**SUMMARY OF DISPUTED COMMENTS
ARKEMA EE/CA WORKPLAN
(2-28-06)**

Subject: Comments on Arkema draft EE/CA Workplan, dated September 26, 2005

Subject: Comments on Arkema draft EE/CA Workplan Responses

Units: International Feet.

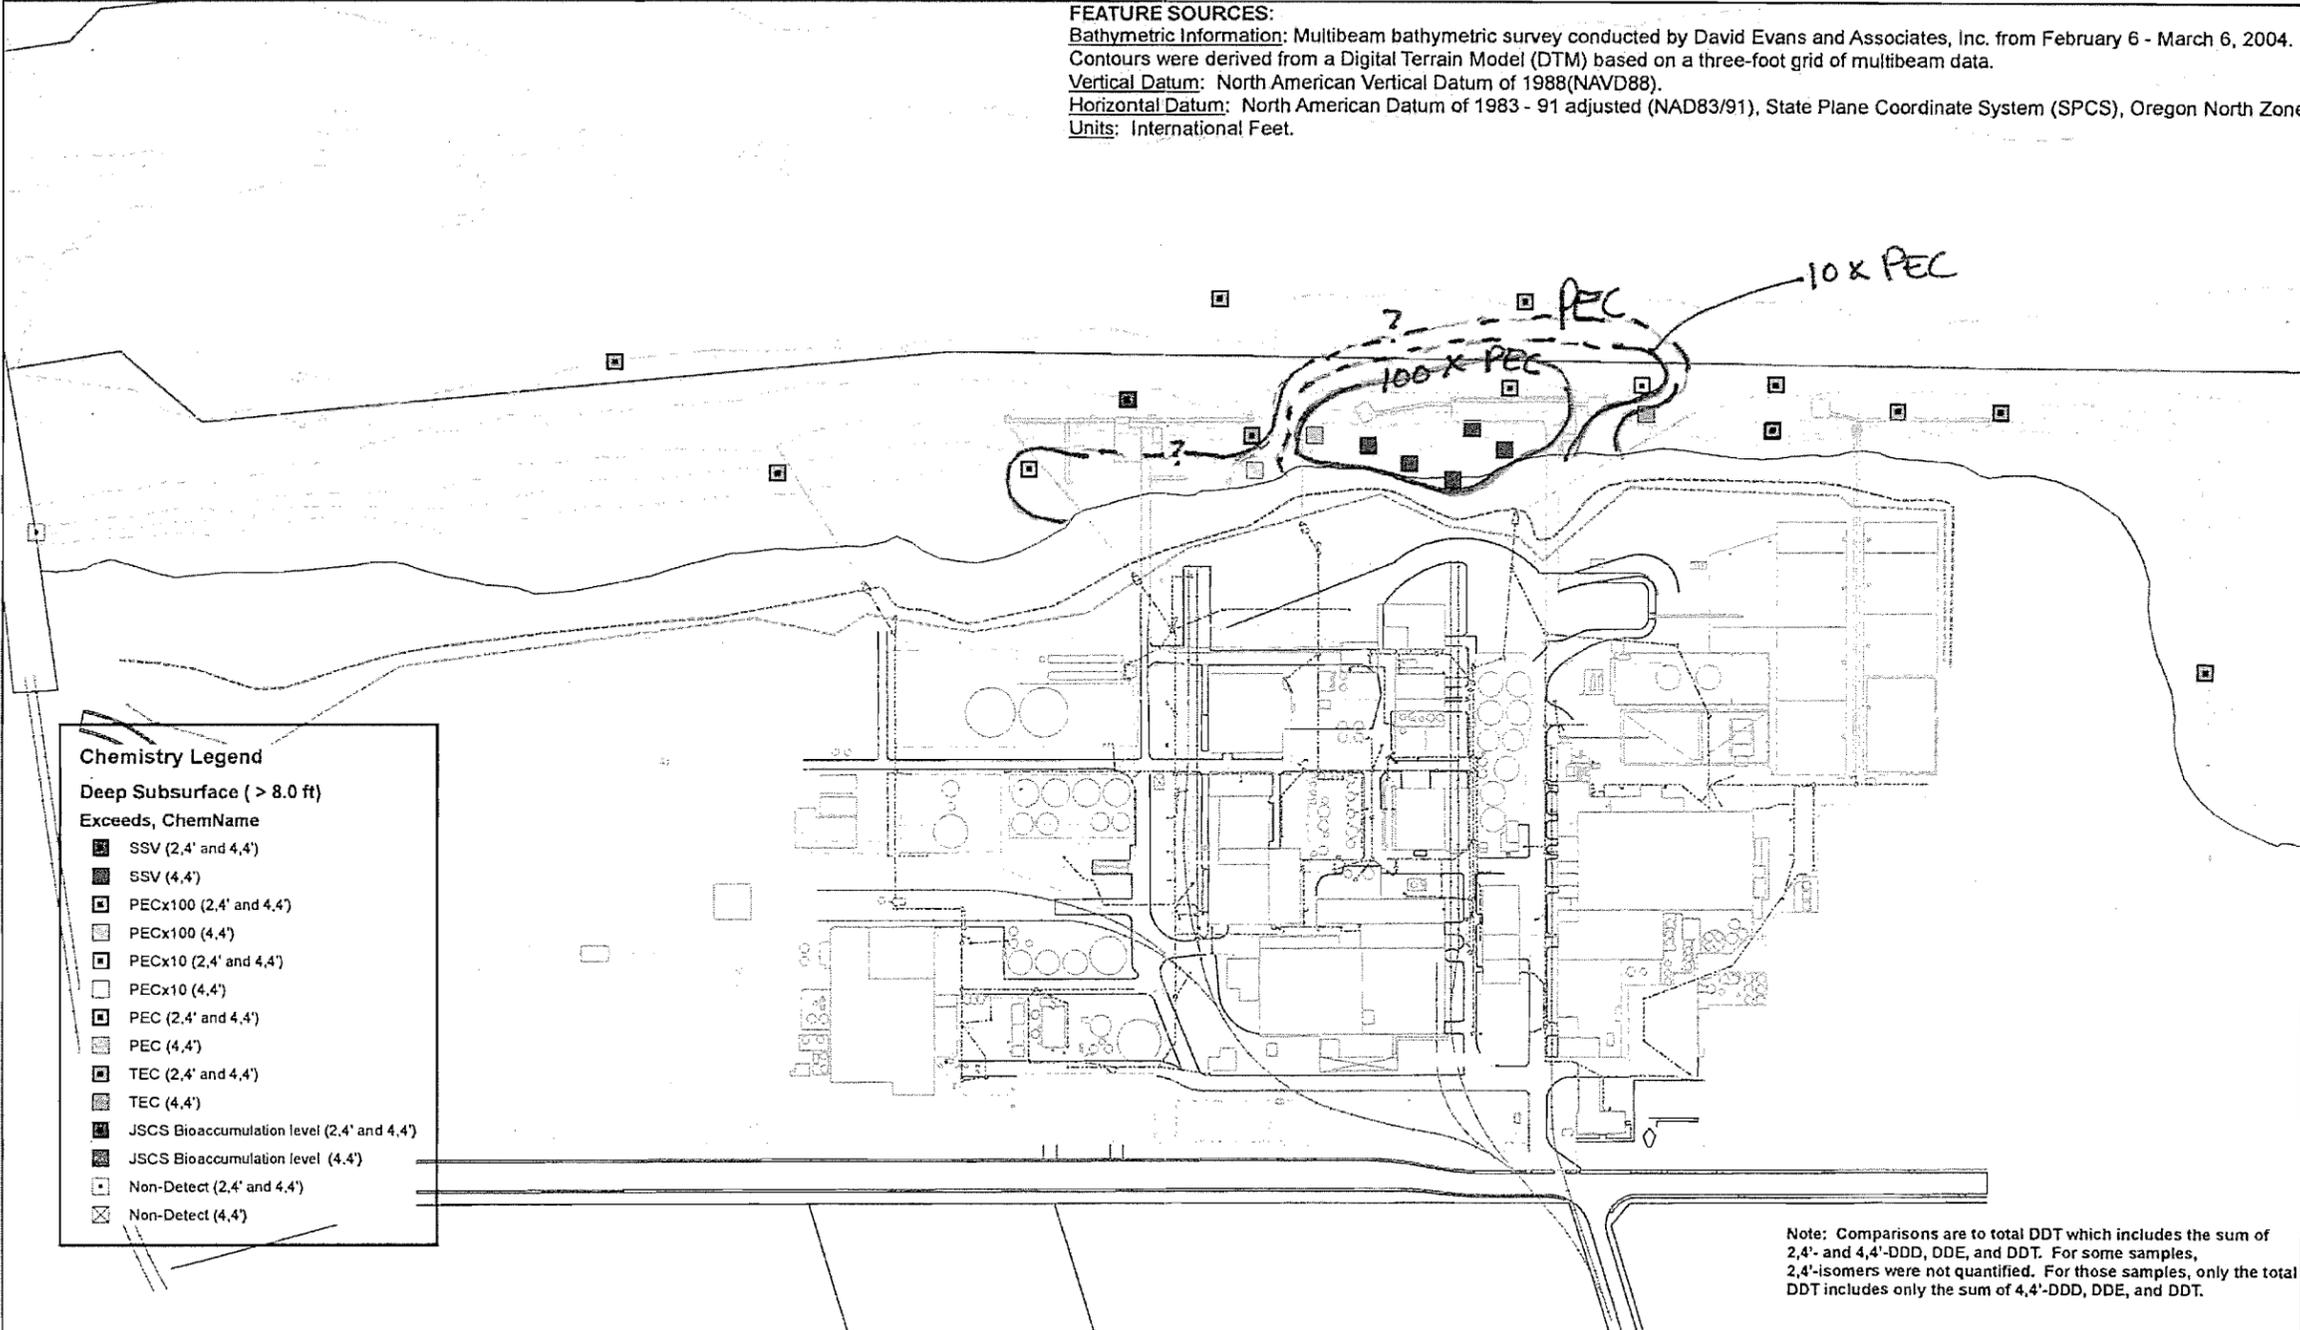
The figure examples presented on February 2, 2006 are a good start. The identification by color and symbol for different screening criteria are useful. The example figures should be expanded to show

chronic and acute screening level values as isopleths. The figures also need to show relevant upland conditions that could contribute to recontamination to and groundwater flux across the preliminary RAA. Upland information should be consistent with the upland information presented in the Upland Remedial Investigation, Lots 3 and 4 and Tract A- Revision 1.

EPA recognizes that some data sets may not meet the geo-spatial or data quantity requirements to accurately depict areal extent using iso-concentration contours. We do not expect Arkema to plot contours for data sets involving one or very few data points. EPA does expect, however that Arkema will use professional judgment to create figures that provide information suitable to identify data gaps, sampling objectives and primary risk areas for all relevant pathways.

The information should be presented in a manner that shows the relationship between upland source areas (soil, groundwater), migration pathways (surface run-off, stormwater outfalls, groundwater) and chemical distribution in the Willamette River. A rough example (conceptual) of selected information EPA would like to see on drawings is attached.
